STATE OF OHIO
DEPARTMENT OF TRANSPORTATION
BUT IR 75/VAR 5.22/VAR

LOWERING THE PAVEMENT BENEATH 3 BRIDGES IN BUTLER COUNTY

TITLE SHEET

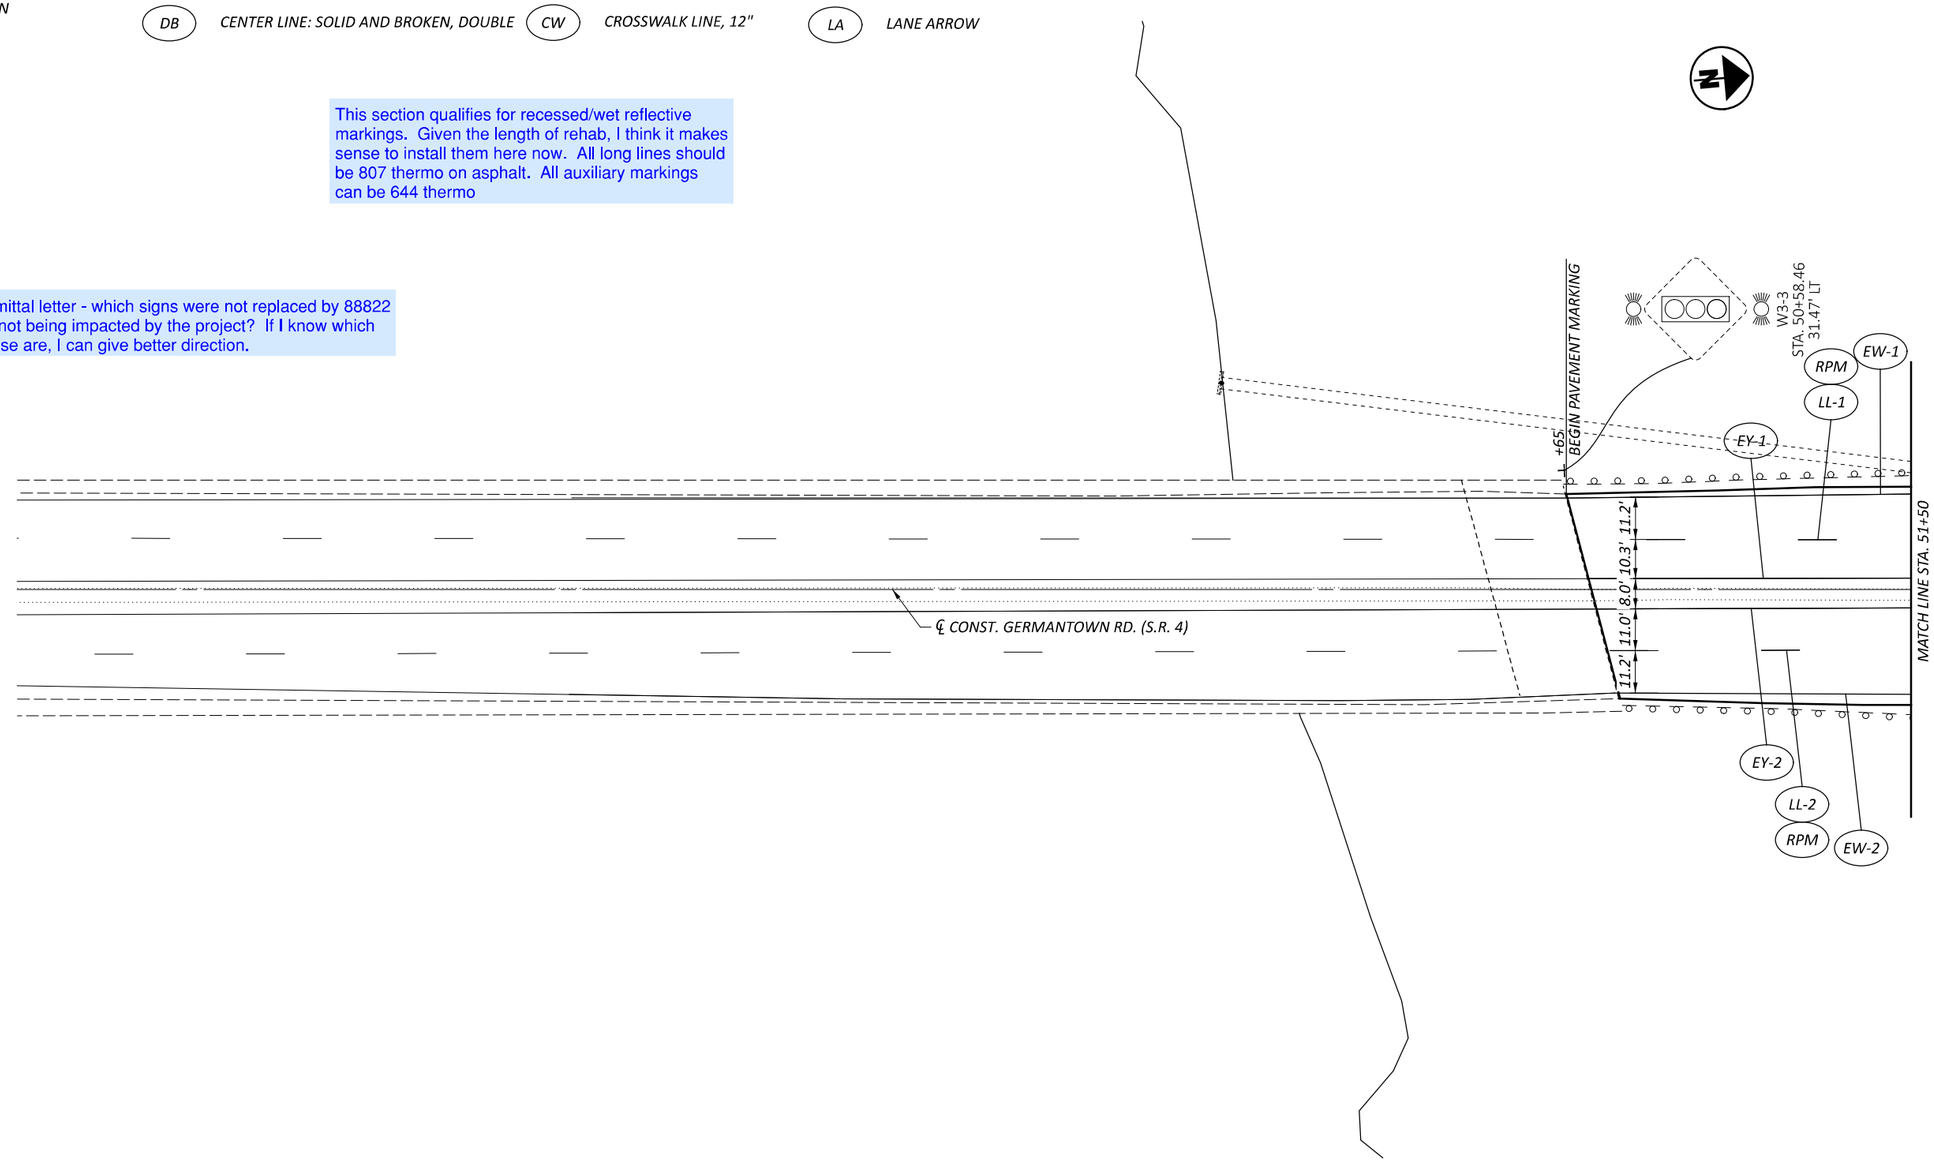
This section qualifies for recessed/wet reflective markings. Given the length of rehab, I think it makes sense to install them here now. All long lines should be 807 thermo on asphalt. All auxiliary markings can be 644 thermo

SIGNING AND PAVEMENT MARKING PLAN
S.R. 4 - BEGIN TO STA. 51+50

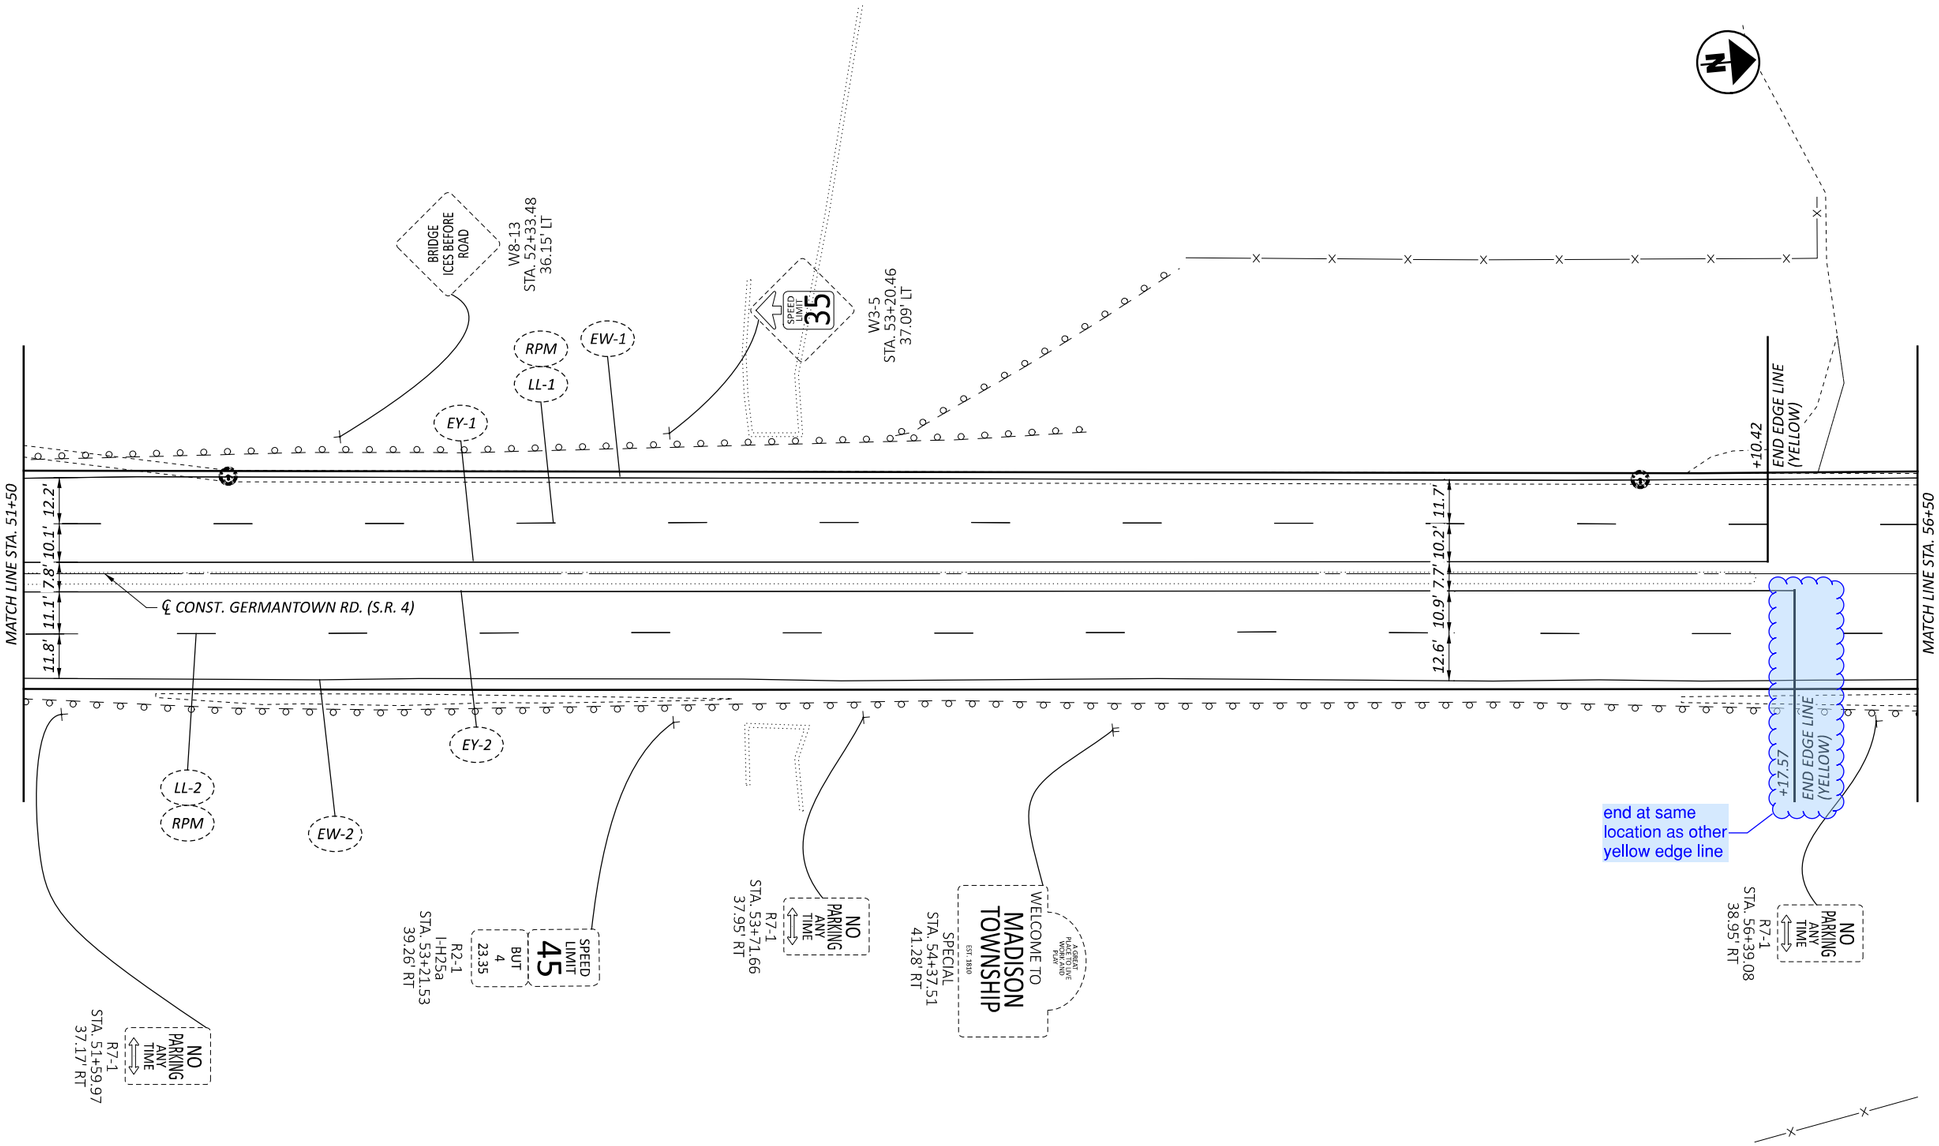
Per submittal letter - which signs were not replaced by 88822 and are not being impacted by the project? If I know which ones those are, I can give better direction.
